CITY OF ALBUQUERQUE

Re: Gibson Shops - Wienerschnitzel
400 Gibson
Traffic Circulation Layout
Architect's Stamp 03-14-18 (L15-D049)

DRAINAGE AND TRANSPORTATION INFORMATION SHEET (REV 09/2015)

GIBSON SHOPS
OVERALL SITE PLAN
1400 GIBSON BLVD
ALBUQUERQUE, NM
PROJECT #1662

1 SITE PLAN
1" = 20'-0"

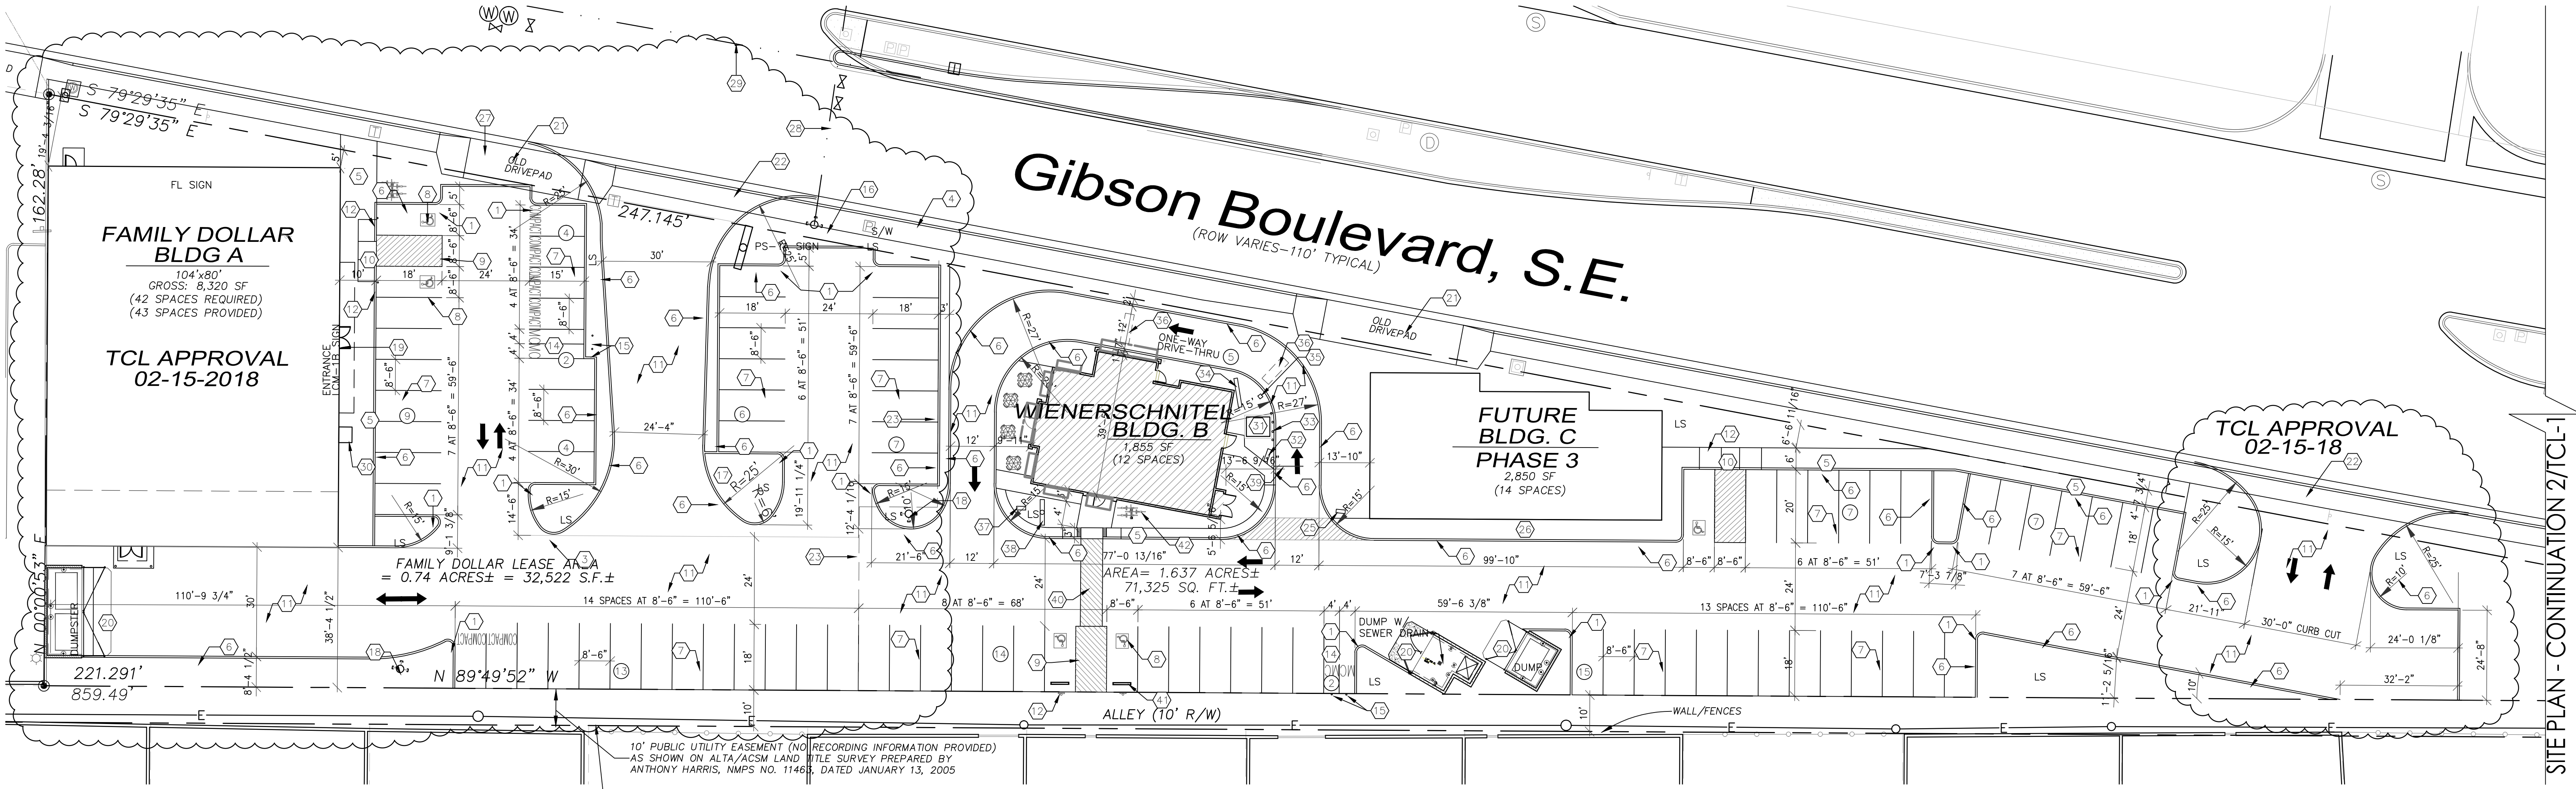
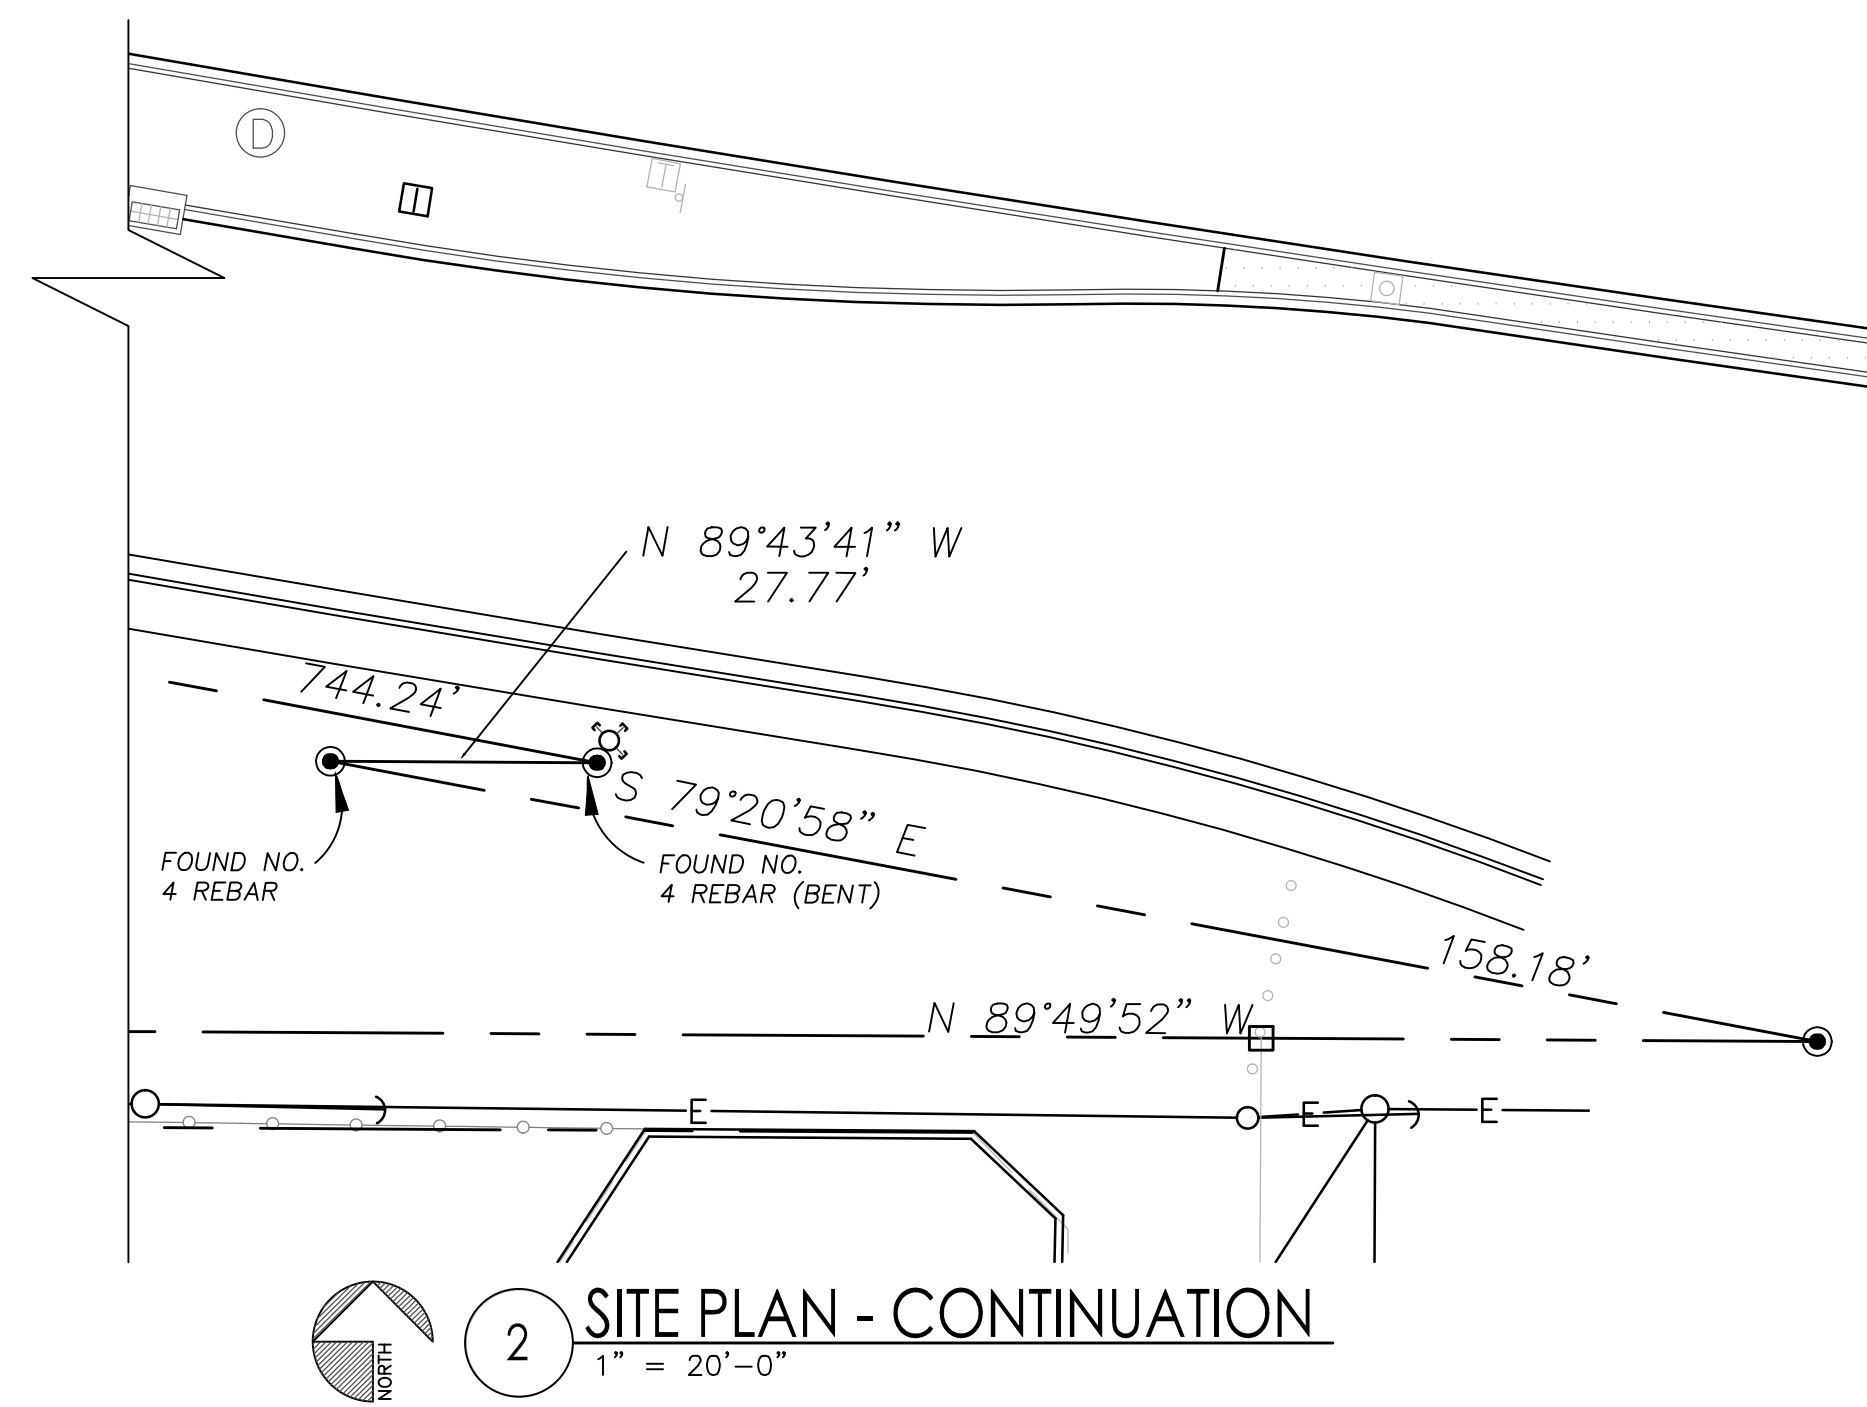
1. One-way vehicular paths require pavement directional signage and a posted **"Do Not Enter"** sign at the point of egress. Please show detail and location of posted signs.
2. The minimum drive through lane width is 12 feet with a 25 foot minimum radius (inside edge) for all turns. (A 15 foot radius can be used with an increase in lane width to 14 feet). Please dimension all lane widths and radii.
3. Please add a note on the plan stating "All improvements located in the Right of Way must be included on the work order."
